**SIERRA
CLUB**

April 8, 2018

We are writing to you about the Department of Water Resources' cost-benefit analysis for the WaterFix project. The February 2018 WaterFix cost-benefit analysis by David Sunding discusses the risks and potential economic costs of export curtailment due to multiple levee failures from a Maximum Considered Earthquake (MCE) on the Hayward-Rogers Creek fault.¹ Sunding's cost-benefit analysis implies that construction of the Waterfix tunnels would result in no reduction in State Water Project and Central Valley Project exports in the event of such an earthquake. This is severely misleading and inaccurate.

2 WaterFix tunnel lining design

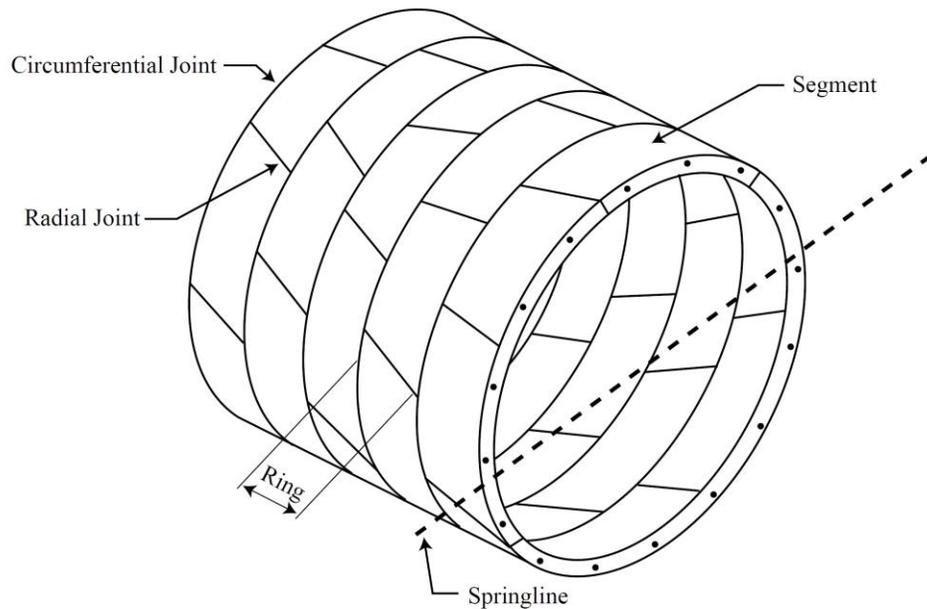
It is clear that cost is driving the current tunnel lining design. The Department of Water Resources and Metropolitan Water District *must* fully analyze and disclose the tradeoffs between cost and strength of the tunnel lining design, including potential leakage in a 2% in 50 year earthquake on nearby faults.

DELTA RISK MANAGEMENT STRATEGY CALIFORNIA	TIME DEPENDENT SEISMIC HAZARD CURVES FOR MEAN PEAK HORIZONTAL ACCELERATION FOR CLIFTON COURT FOR 2005	Figure 6-7
	Project No. 26815900

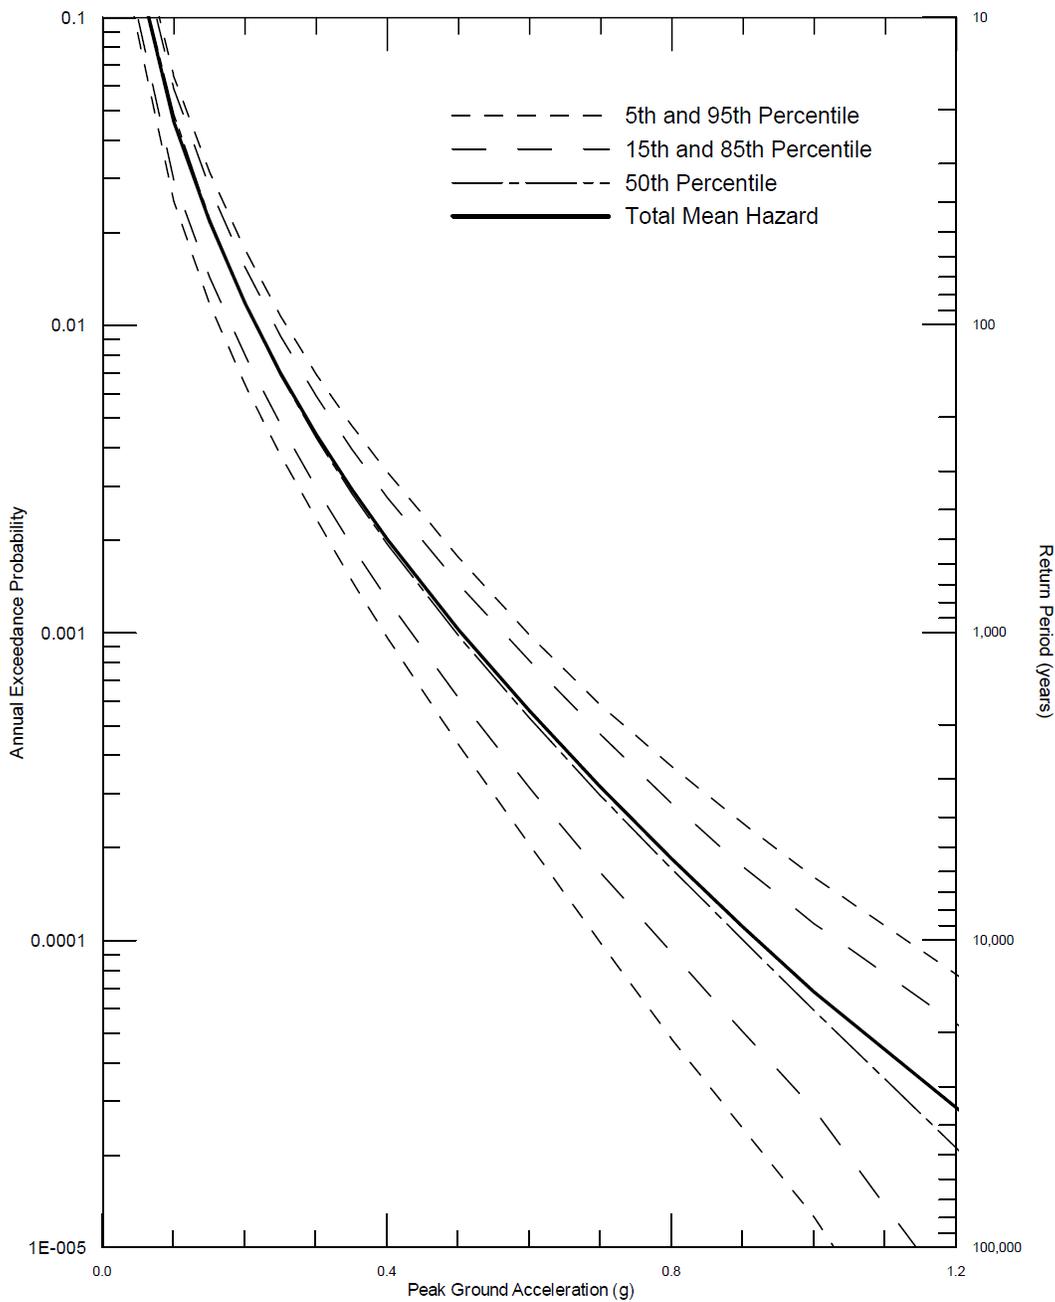
³ The longer the return period, the larger the earthquakes that are likely to occur. The probabilistic hazard curve for Clifton Court Forebay from the Delta Risk Management Strategy is shown at the end of this letter.

3 Probabilistic ground motions for Clifton Court Forebay. Includes probability of quakes from all nearby faults.
